Docket Item #4
Development Site Plan #2023-00012 550
South Pickett Street
Avanti 550 Retail Building

Purpose of Application
The applicant requests approval of a Development Site Plan with modifications to construct a new retail building.
Applications/Special Use Permits/Modifications Requested:
Development Site Plan to construct a new retail building with a modification of the 50-foot setback from the centerline of South Pickett Street.

Staff Recommendation: APPROVAL WITH CONDITIONS
Staff Reviewers: Robert M. Kerns, AICP, Division Chief robert.kerns@alexandriava.gov Nathan Randall, Principal Planner nathan.randall@alexandriava.gov Leon Vignes, AICP, Urban Planner bert.vignes@alexandriava.gov

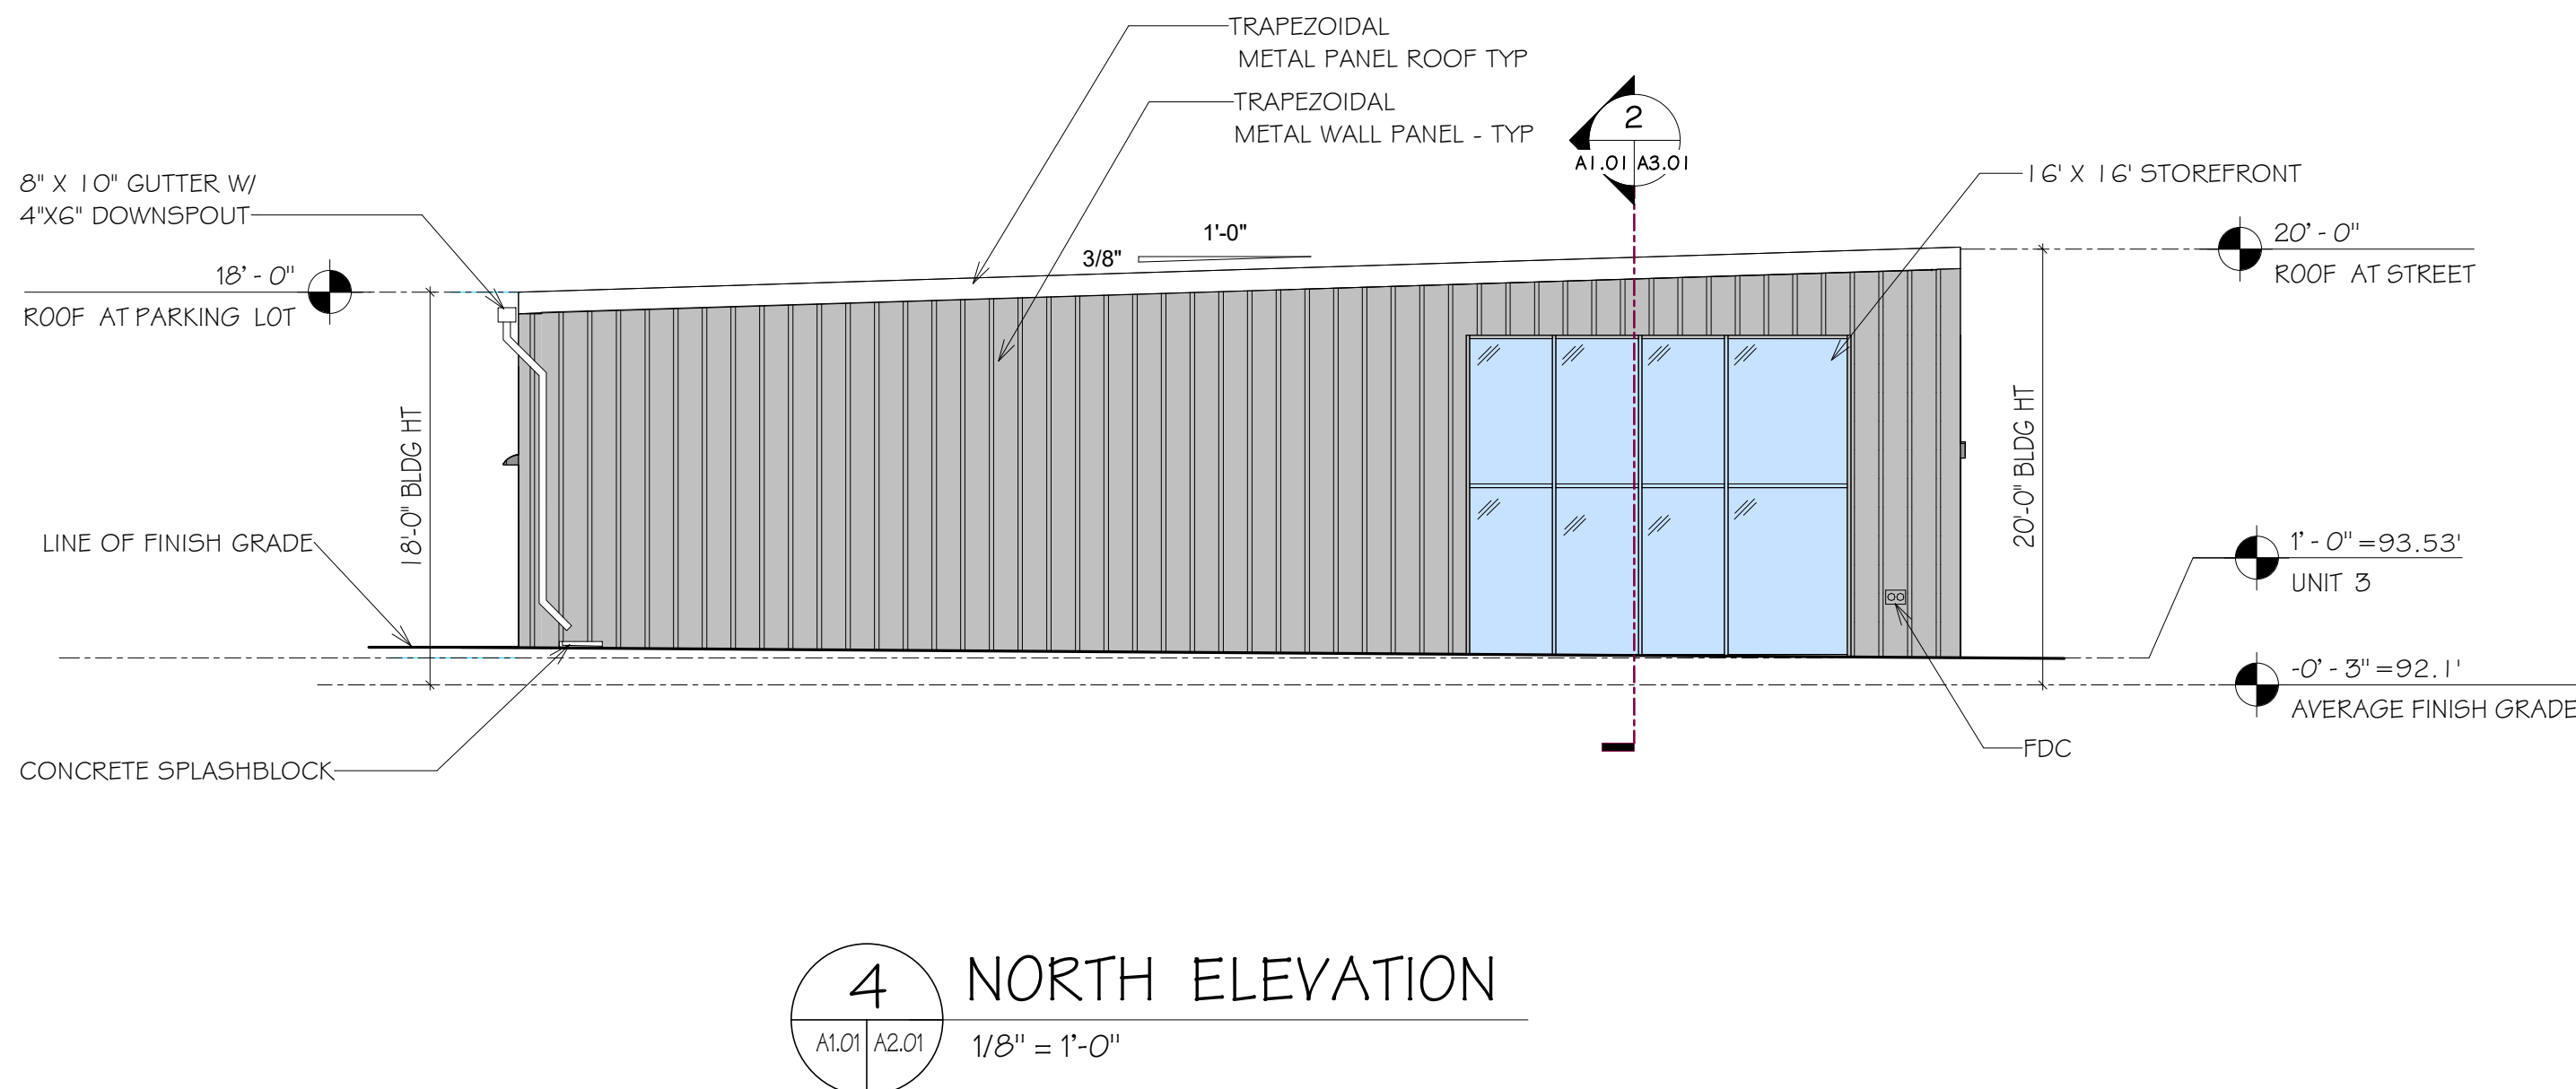
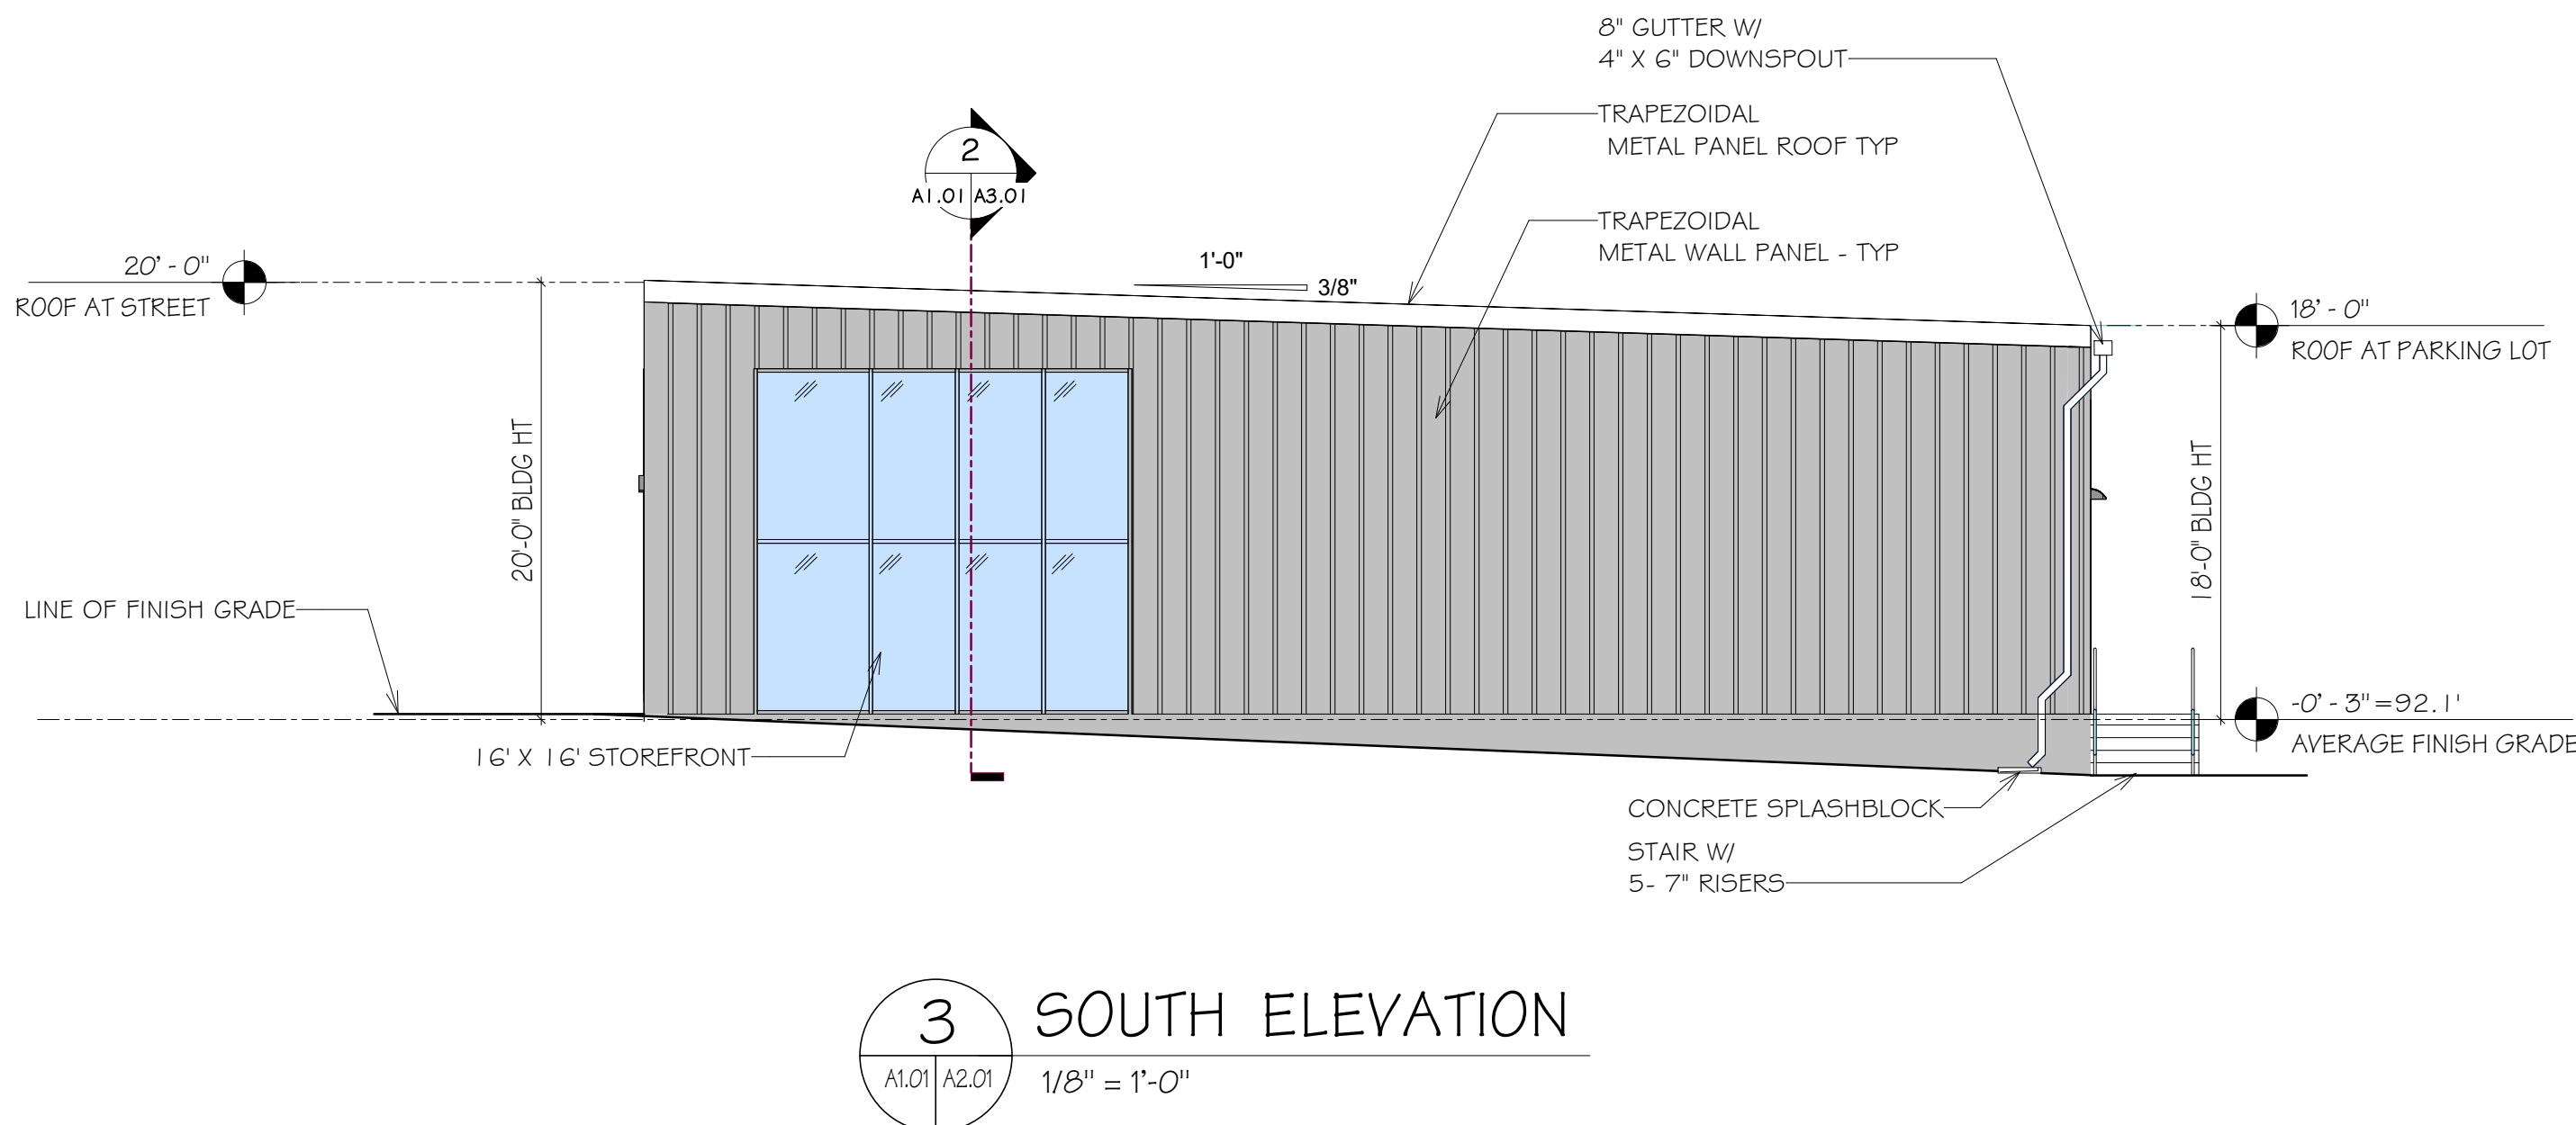
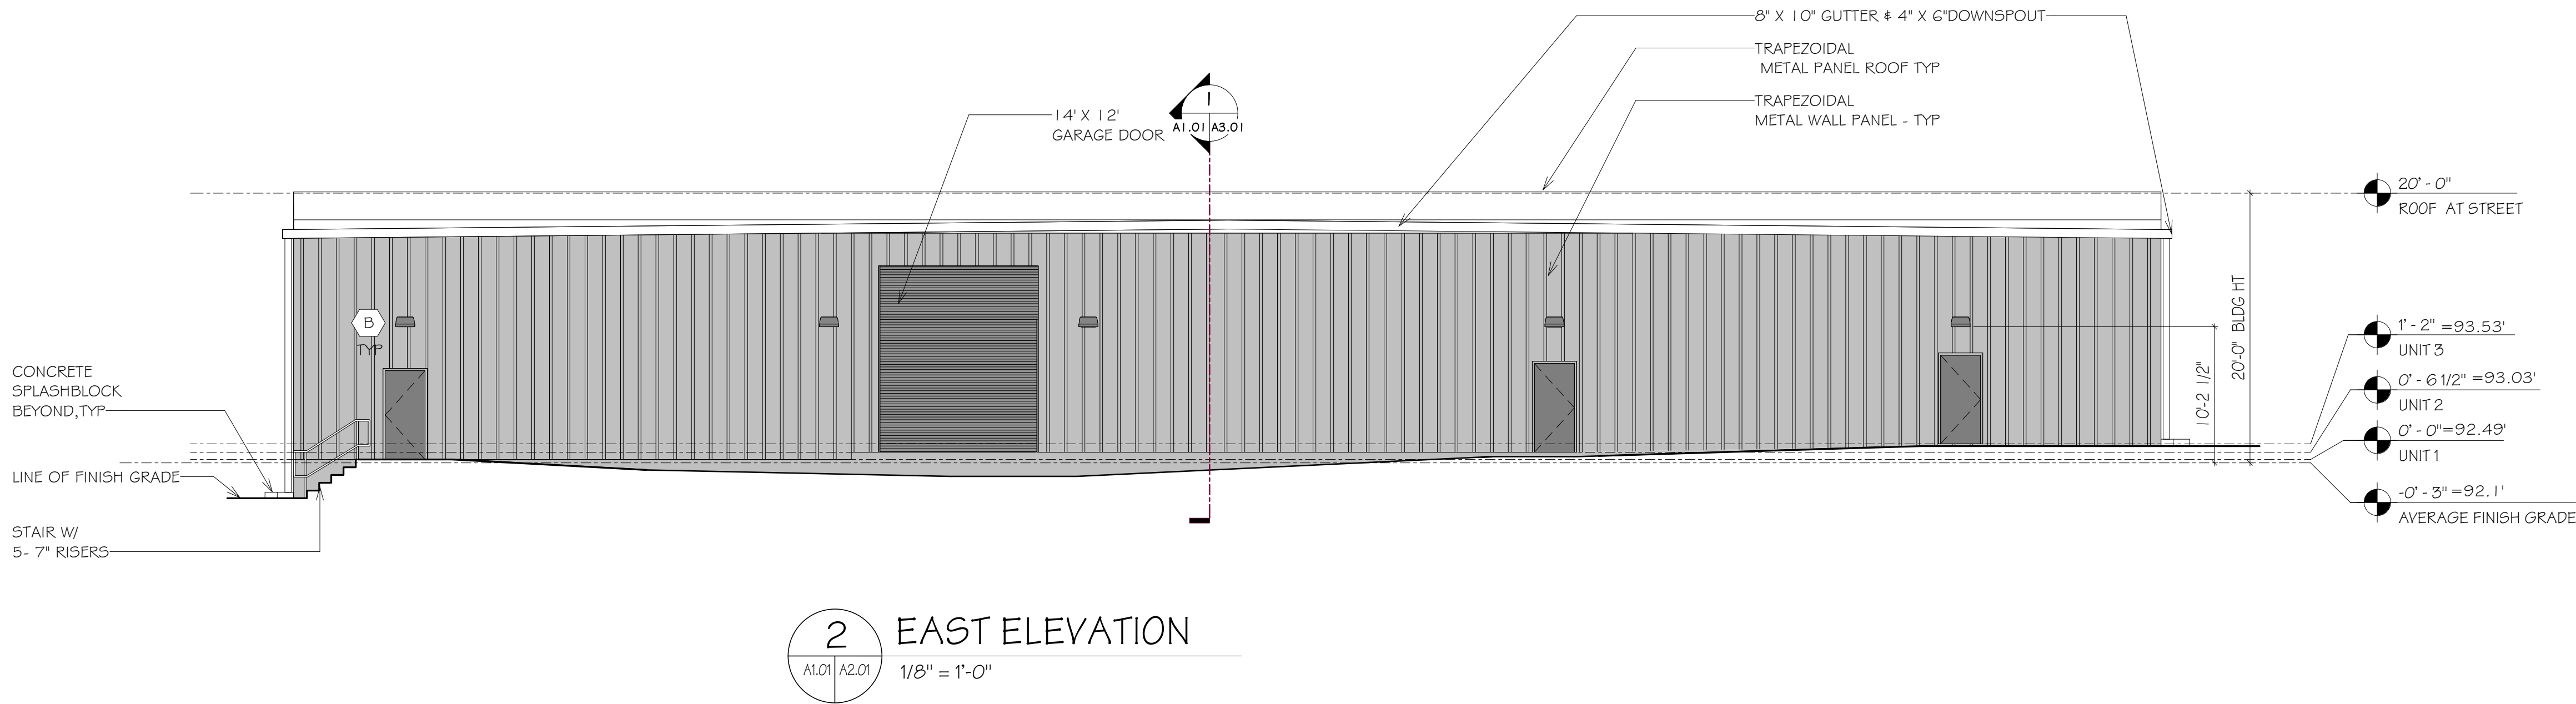
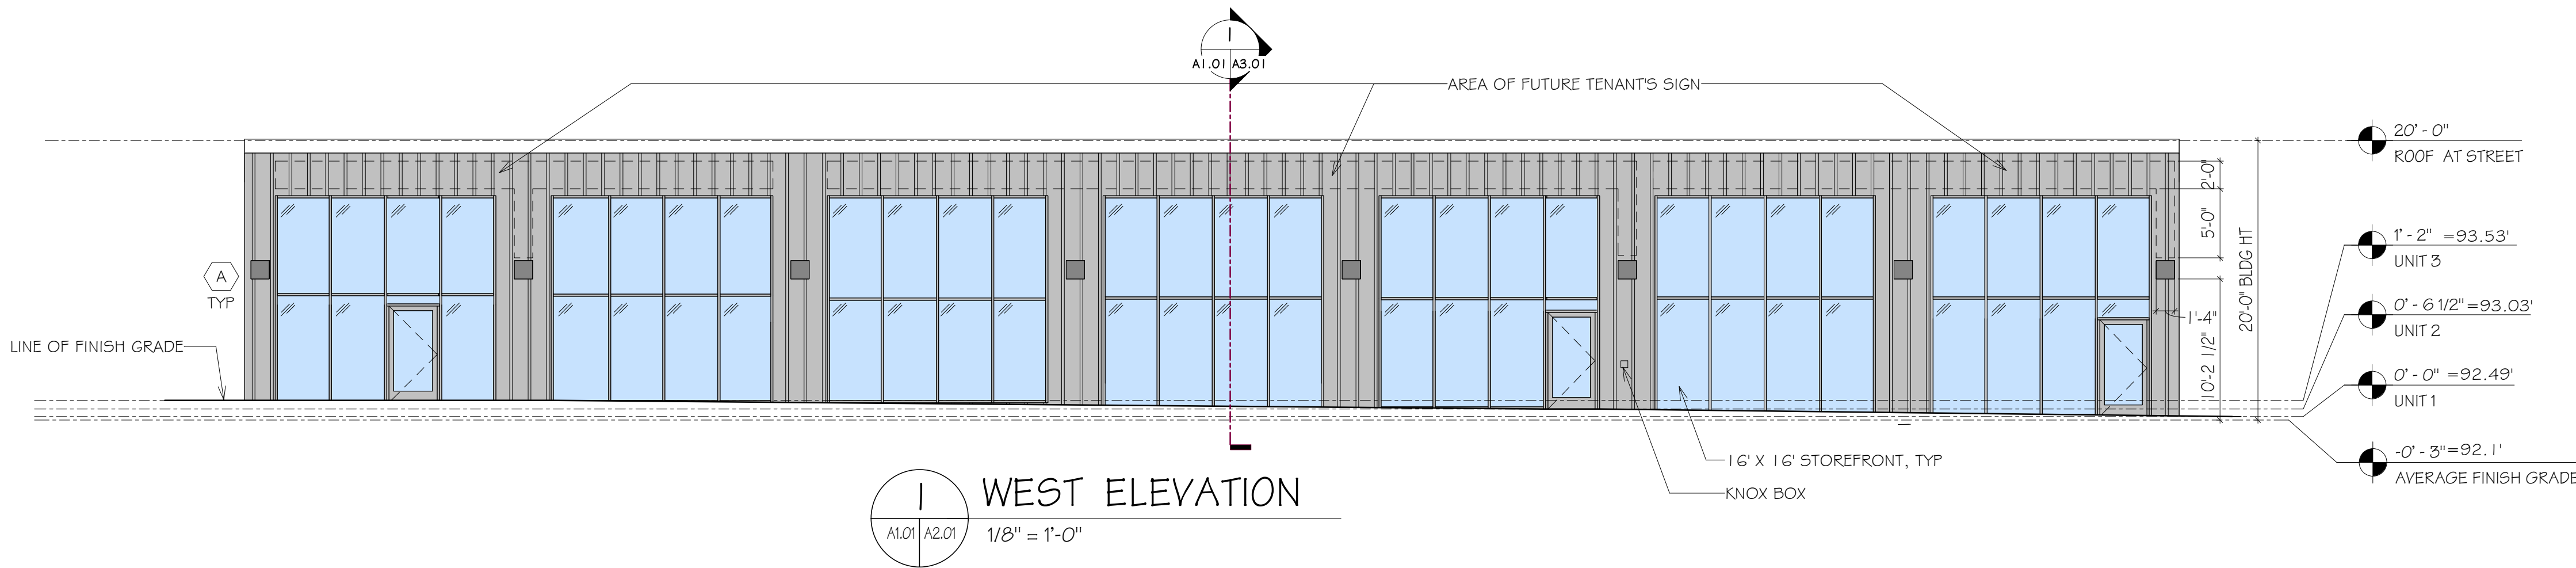
Comment 3: Please label actual finished grade on Sheets A.201 and A.301 (elevation and section drawings).

Response: The average finished grade has been labeled on both sheets. Please see sheets A.201 and A.301

Response: The area for future signs is shown on the west elevation on sheet A2.01.
